Access Compliance Report Public Rights-of-Way (Curb Ramps)

Intersection ID: 23895 Main Street: BATTLE FOREST DR Cross Street: REA_RD Location: NW ADA ID: 6A8CE946018F Ramp Type: PerpDiag Initial Pass/Fail: Fail **Overall Compliance: No Severity Score:** 25

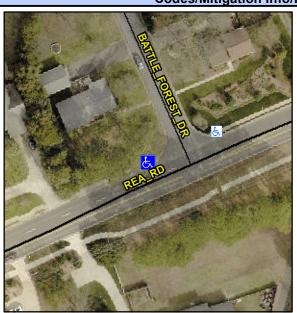
Field Measurements/Component Compliance					
Compliance Description		Data	Compliance Description		Data
N/A	Ramp Length (in)	43.0	No	Ramp Slope (%)	11.7
Yes	Ramp Width (in)	60.0	No	Ramp XSlope (%)	5.1
N/A	Flare Type LT	N/A	N/A	Flare Type RT	N/A
N/A	Flare Slope LT (%)	N/A	N/A	Flare Slope RT (%)	N/A
N/A	Flare Traversable LT?	N/A	N/A	Flare Traversable RT?	N/A
N/A	Landing Length (in)	N/A	N/A	DWS Provided?	N/A
N/A	Landing Width (in)	N/A	N/A	DWS Contrast?	N/A
N/A	Landing Slope (%)	N/A	N/A	DWS Length (in)	N/A
N/A	Landing X Slope (%)	N/A	N/A	DWS Full Width?	N/A
N/A	Landing Curb? (Y/N)	N/A	N/A	DWS Offset (in)	N/A
N/A	Shared Landing?	N/A			
N/A	Gutter Ponding?	N/A	N/A	Gutter Slope (%)	N/A
N/A	Gutter Lip Ht (in)	N/A	N/A	Gutter X Slope (%)	N/A
N/A	Painted X Walk1?	No	N/A	Painted X Walk2?	No
	X Walk 1 Direction	To SE		X Walk 2 Direction	To NE
N/A	X Walk 1 Width (in)	N/A	N/A	X Walk 2 Width (in)	N/A
	X Walk 1 Slope (%)	4.8		X Walk 2 Slope (%)	1.7

Possible Solutions: Remove & Replace Curb Ramp With Two New Directional Ramps or Equivalent. Surveyor Notes: N/A PROW/ADA: R304.2.2, R304.5.3
